REVISION	DATE	DESCRIPTION	BY
3	Jul 90	As built - No change	D.S.
4	13 May 88	Added Interceptor Ditch No. 1	T.D.
DEPARTMENT OF THE ARMY NEW YORK DISTRICT, CORPS OF ENGINEERS NEW YORK, NEW YORK			
DRAWN BY: <i>EJM</i>		SAW MILL RIVER, NEW YORK	
CHECKED BY: <i>D.S.</i>		ARDSLEY FLOOD CONTROL PROJECT	
DESIGNED BY: <i>Thomas J. ...</i>		MAIN CHANNEL PROFILE	
REVIEWED BY: <i>James ...</i>		ARDSLEY	
SUBMITTED: <i>C. ...</i>		RECOMMENDED: <i>Stanley ...</i>	
APPROVED: <i>W. ...</i>		SCALE AS SHOWN	
DATE: 20 JULY 1987		DRAWING NUMBER: CC-ARD-411	
		SHEET 11 OF 48

Designed by: 	SAW MILL RIVER, NEW YORK
Drawn by: EJM	ARDSLEY FLOOD CONTROL PROJECT
Checked by: D.S.	PROFILES-INTERCEPTOR
	DITCHES NO. 1 & 2
Reviewed by: 	ARDSLEY CHIEF, ENGINEERING DIVISION
Approved by: 	Sheet reference number: CC-ARD-413
Concurred by: 	Date: 20 JULY 1987
ASST. CHIEF, DESIGN BRANCH	Scale: AS SHOWN
	Sheet 13 of 44

SAW MILL RIVER, NEW YORK
ARDSLEY FLOOD CONTROL PROJECT
CROSS SECTIONS—STA 0+27U TO STA 8+02U

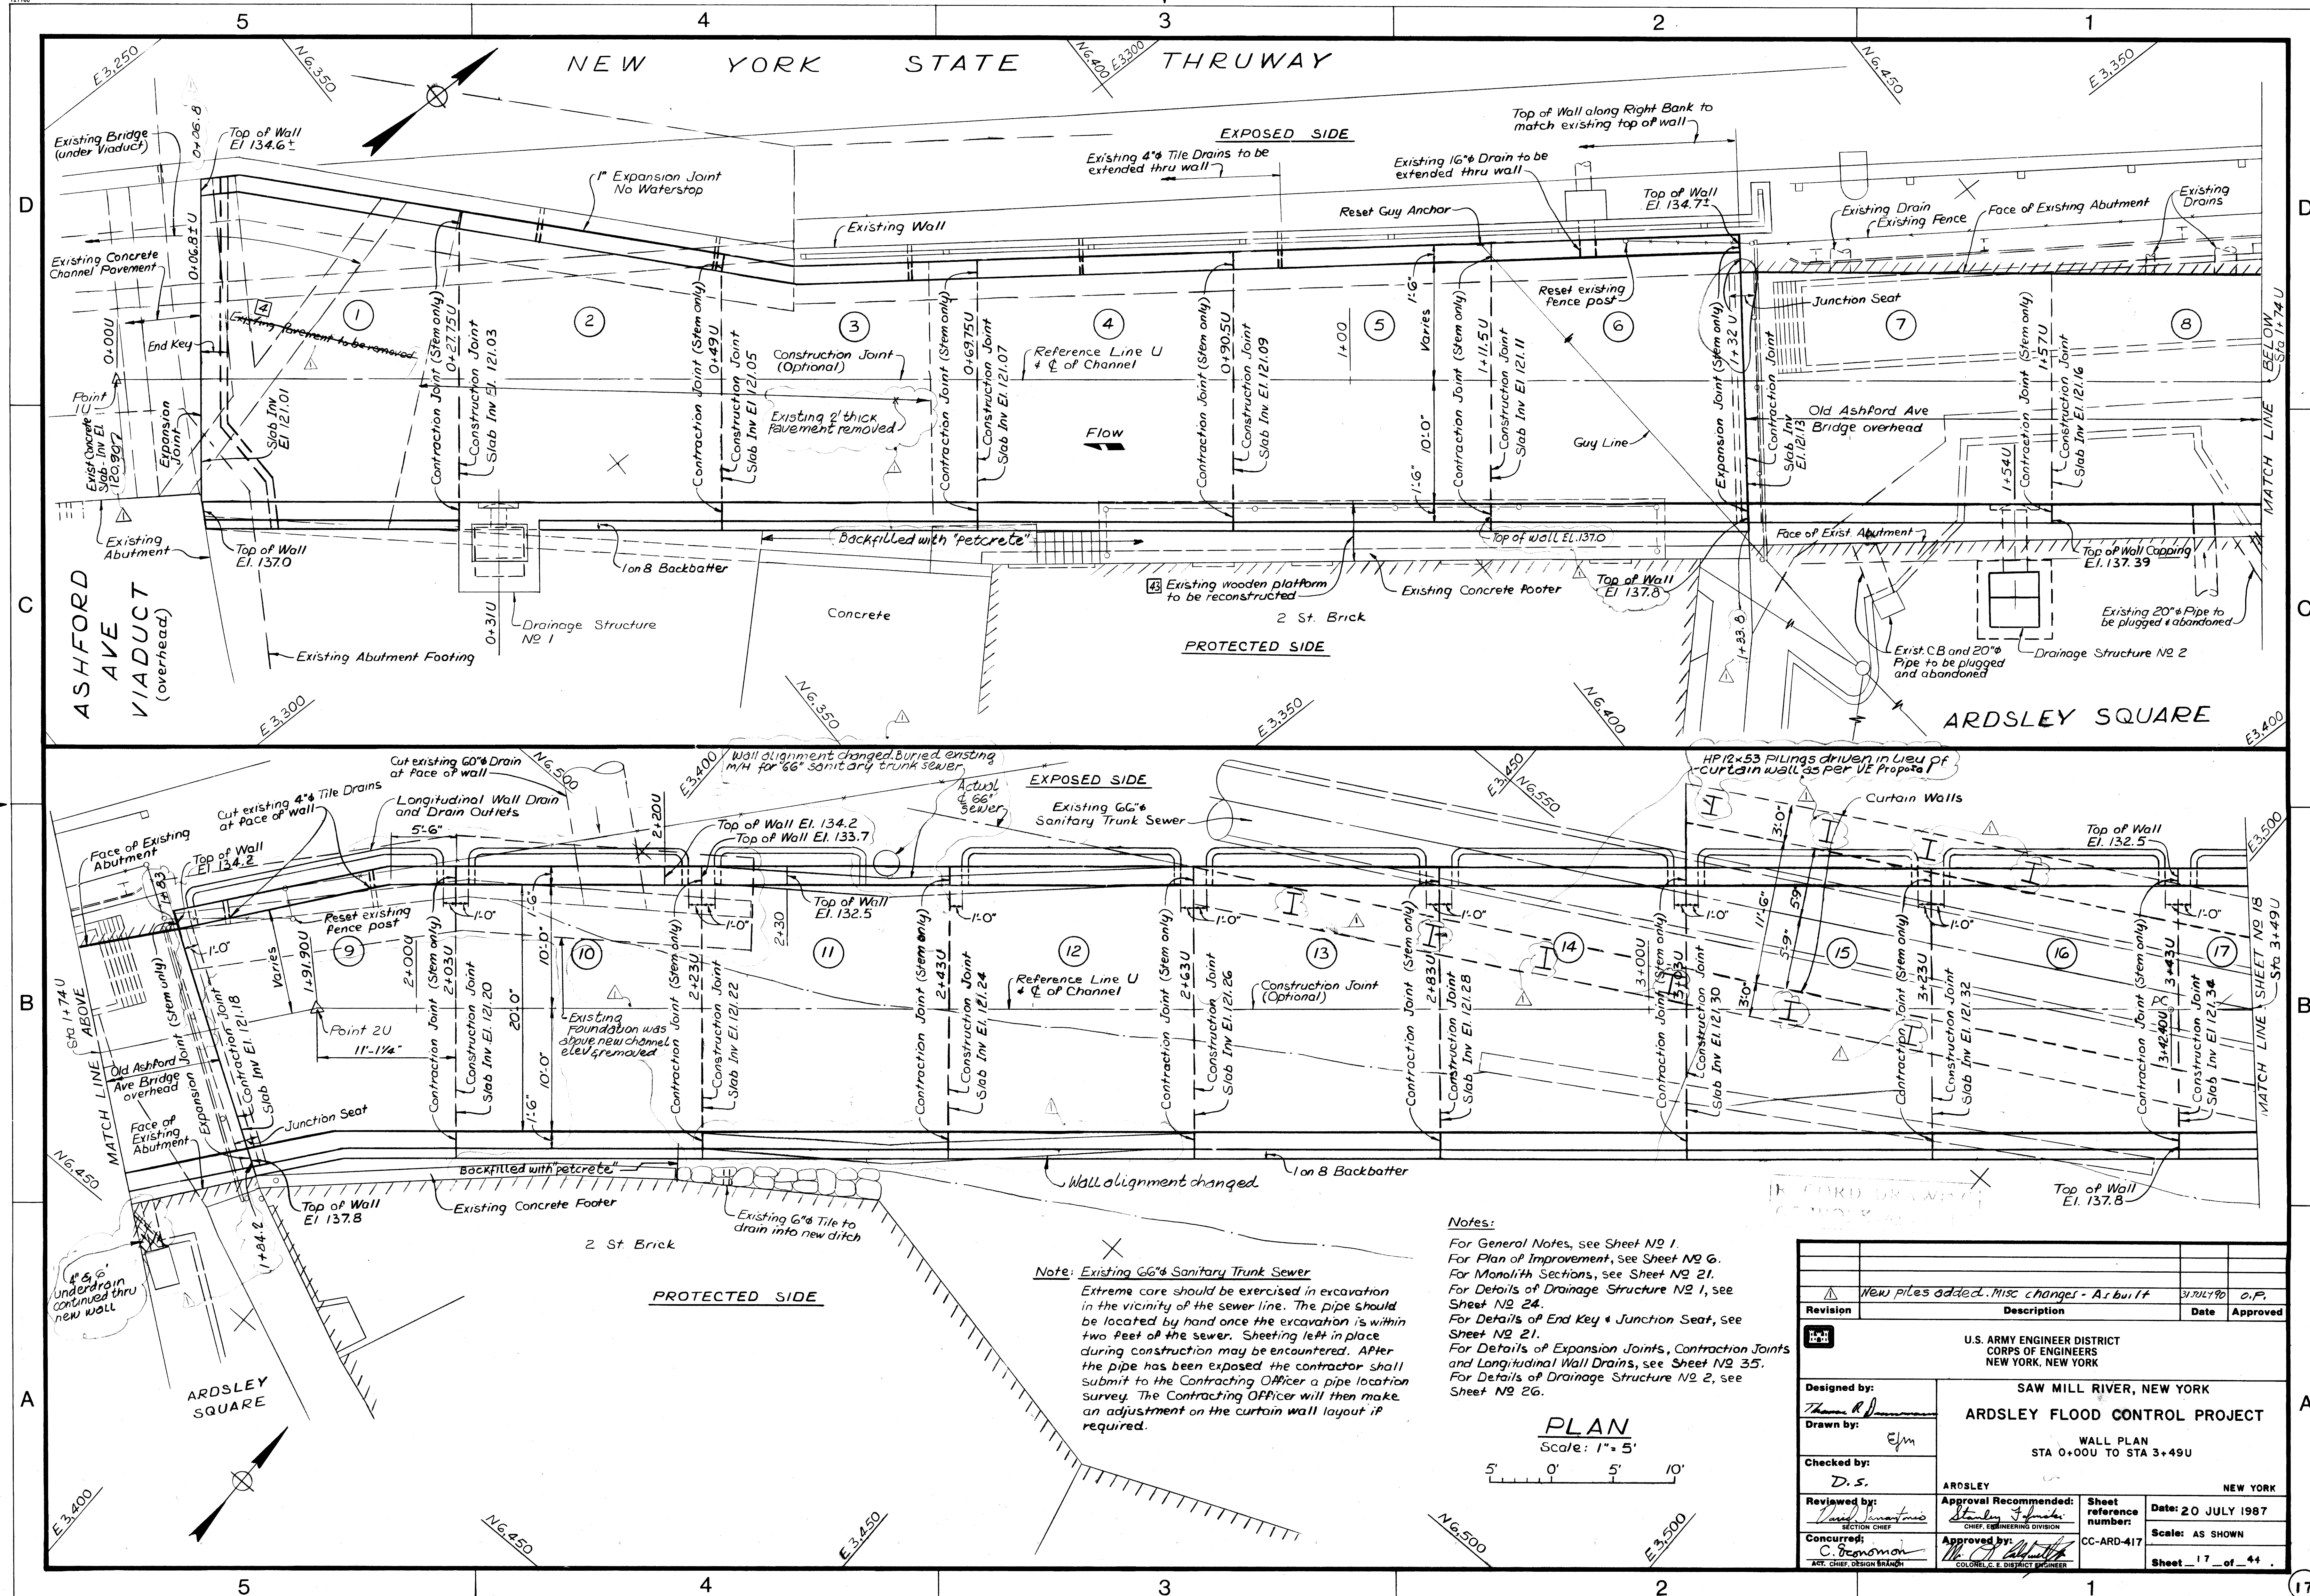
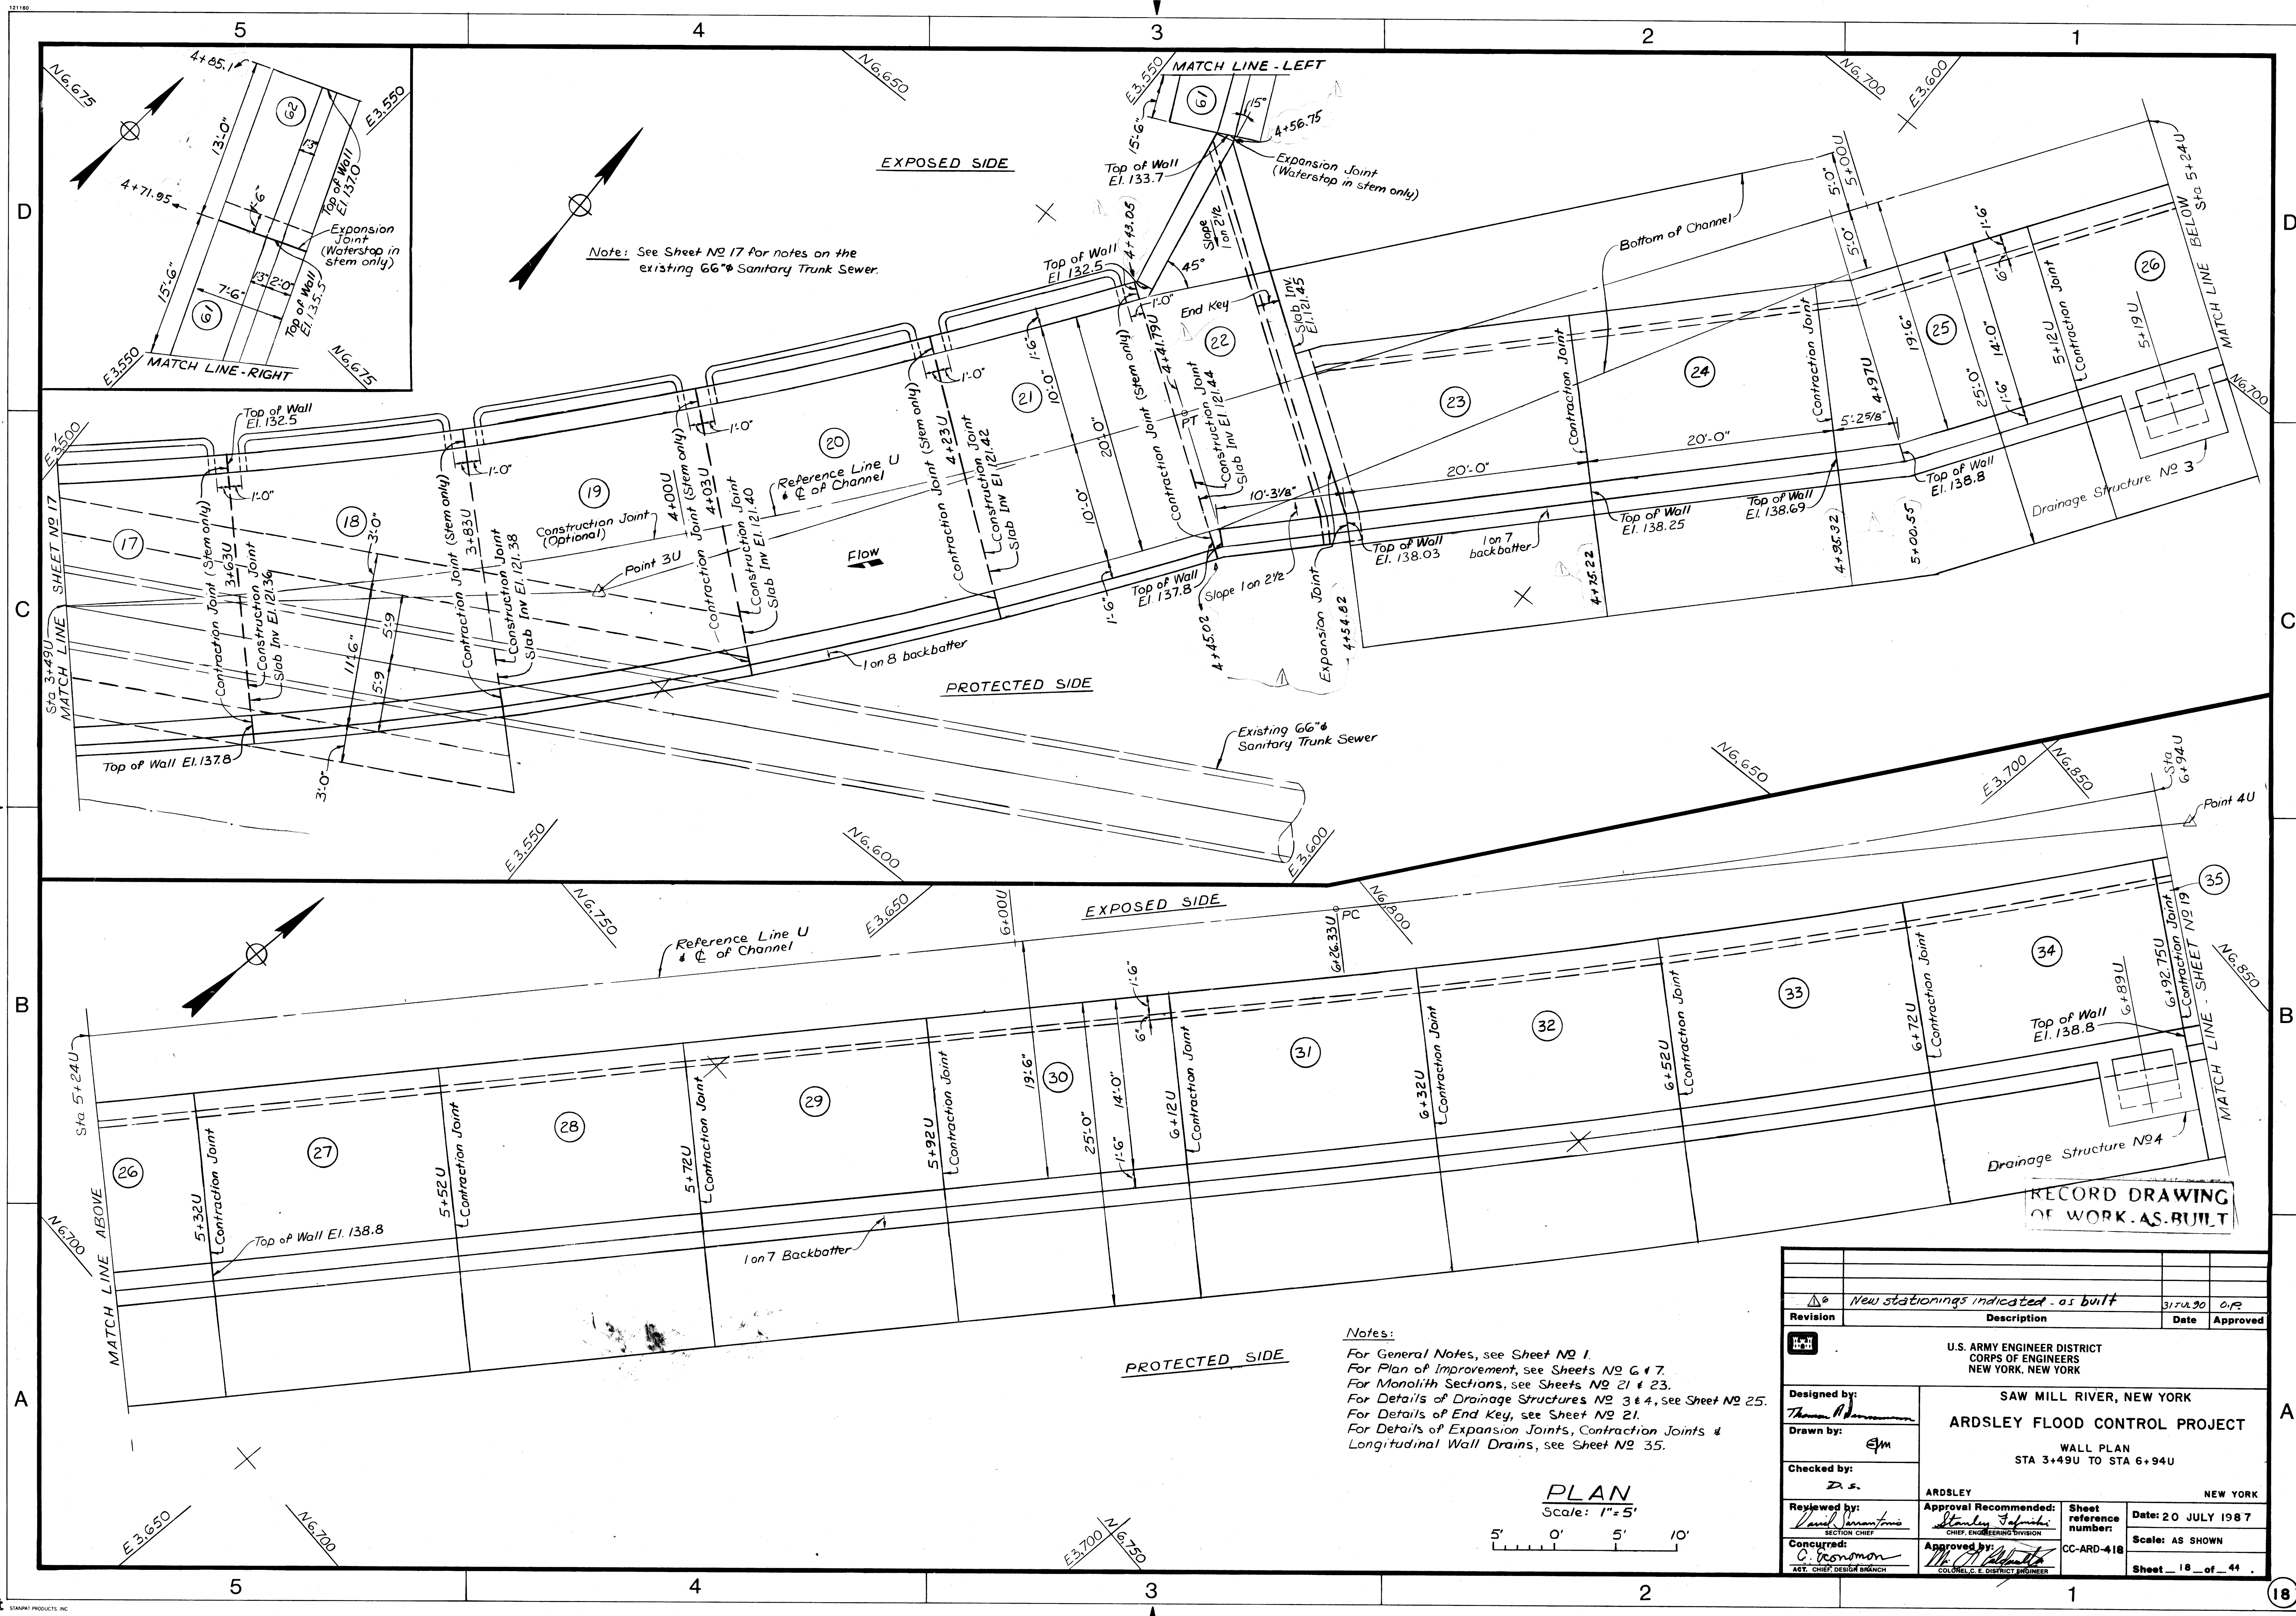
New stationings indicated - as built		31 JUL 90	O.P.
Revision	Description	Date	Approved
U.S. ARMY ENGINEER DISTRICT CORPS OF ENGINEERS NEW YORK, NEW YORK			
Designed by: Thomas P. ...		SAW MILL RIVER, NEW YORK	
Drawn by: EJM		ARDSLEY FLOOD CONTROL PROJECT	
Checked by: D.S.		WALL PLAN STA 3+49U TO STA 6+94U	
Reviewed by: Stanley J. ...		NEW YORK	
Concurred by: C. ...		Approval Recommended: Stanley J. ...	Sheet reference number: CC-ARD-418
Approved by: C. ...		Date: 20 JULY 1987	Scale: AS SHOWN
ASST. CHIEF, DESIGN BRANCH		Sheet 18 of 44
